Safety Evaluation Report

Related to the License Renewal of the
Virgil C. Summer Nuclear Station

Docket No. 50-395

January 2004

**Figure 1: Wear Degradation of Components in the Extraction Steam System:
Theory vs. Actual**

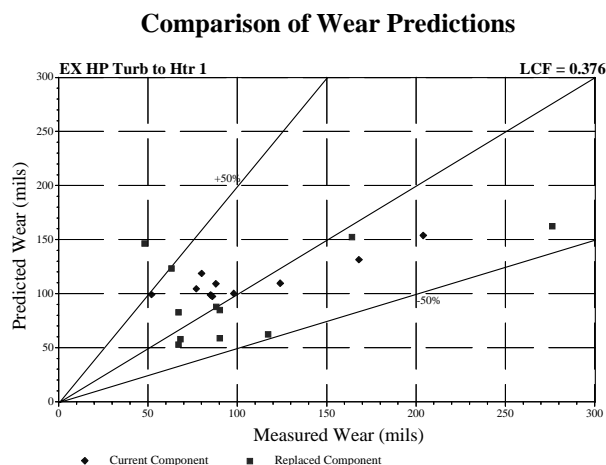
RAIs B.1.6-2 and B.1.6-3, the applicant to list those systems, within the program's scope, most susceptible to FAC. The staff also requested a sample list of components susceptible to FAC with each component's initial, current, and future predicted wall thicknesses, to demonstrate the effectiveness of the Flow-Accelerated Corrosion Monitoring Program. In its response dated June 12, 2003, the applicant stated that the Flow-Accelerated Corrosion Monitoring Program will detect loss of material due to FAC prior to the loss of component intended function. The applicant referenced the October 1992 NRC Inspection Report 50-395/92-20, which stated, "The licensee has established an effective program to maintain high energy carbon steel piping systems within acceptable wall thickness limits." The staff finds that while the referenced inspection report affords some assurance of the effectiveness of the Flow-Accelerated Corrosion Monitoring Program, the report did not supply the information sought by the staff. Therefore, the staff requested a list of those systems, within the program scope, and the components most susceptible to FAC, in addition to the initial, current, and future predicted wall thicknesses, to demonstrate the effectiveness of the Flow-Accelerated Corrosion Monitoring Program.

In subsequent correspondence dated September 2, 2003, the applicant discussed the integration of prediction and inspection inherent in its FAC program. The applicant stated the system most susceptible to FAC at VCSNS is the extraction steam system. This conclusion has been confirmed by the applicant's predictive model and the as-found ultrasonic data for many components. The predictive model of record (CHECWORKS™) represents an analysis tool used by the applicant in the selection of problem areas. This model also aids in the inspection scheduling process. Over time, the applicant determined that model predictions with as-found ultrasonic data have returned reasonable agreement. The applicant provided an example of the predicted vs. measured wear comparisons for components in the extraction steam system summarized below.
